PLANNING COMMISSION STAFF REPORT

MEETING DATE: December 5, 2011 **REPORT REVISED:** November 28, 2011
ITEM NUMBER: V.B. – PUBLIC HEARING
FILE NUMBER: **DRB-08-11 / Branagh Development, Inc. (Applicant), Kimberly LLC (Owners) 10 Kimberly Drive:** Consideration of a design review application for a new two-story 2,880 square foot home with an attached 766 square foot 3-car garage on 65,340 square foot lot at 10 Kimberly Drive. (APN 255-120-011).
ZONING: Zone OS-M (Open Space-MOSO)
CEQA STATUS: On June 7, 1999, the Planning Commission issued a Mitigated Negative Declaration of Environmental Impact under CEQA Guidelines Section 15074. The mitigation measures contained in this Mitigated Negative Declaration are still applicable to the project.

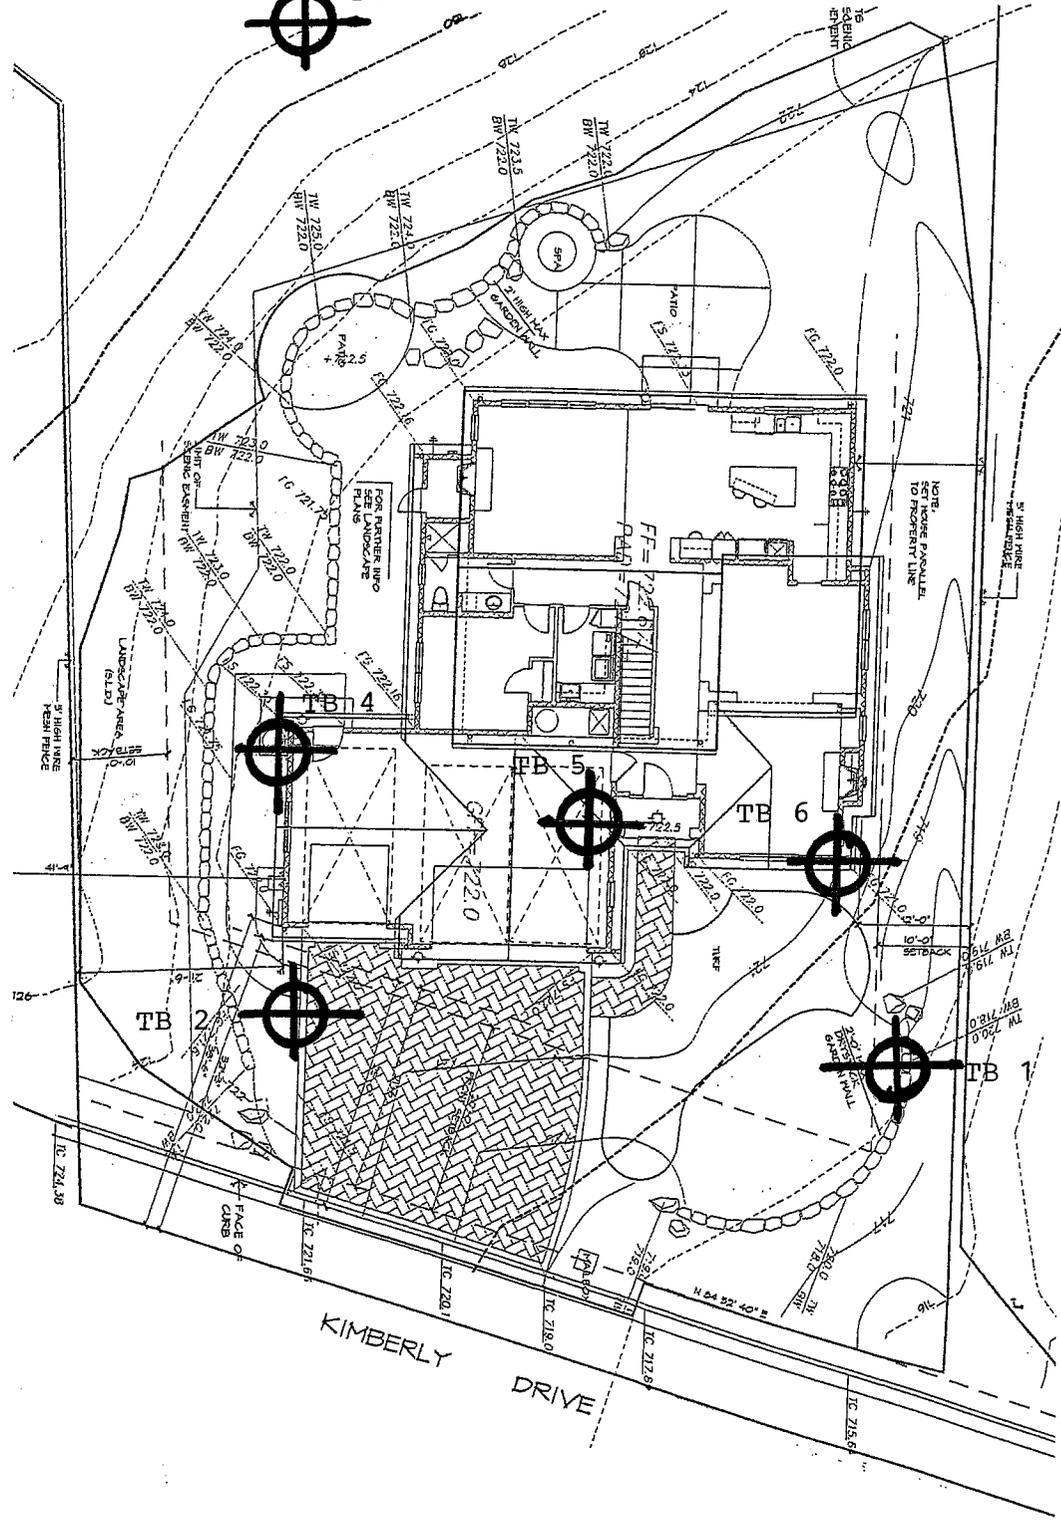
Section 2. Geotechnical Conditions of the JVLA report indicates that the locations of Borings 8, 9, and 10 are shown on Figure 1. Our review of Figure 1 indicates that only borings 1, 2, and 3 are shown on the map. It is recommended that JVLA provide an explanation of the apparent conflict between the text of the report and the information shown on Figure 1.
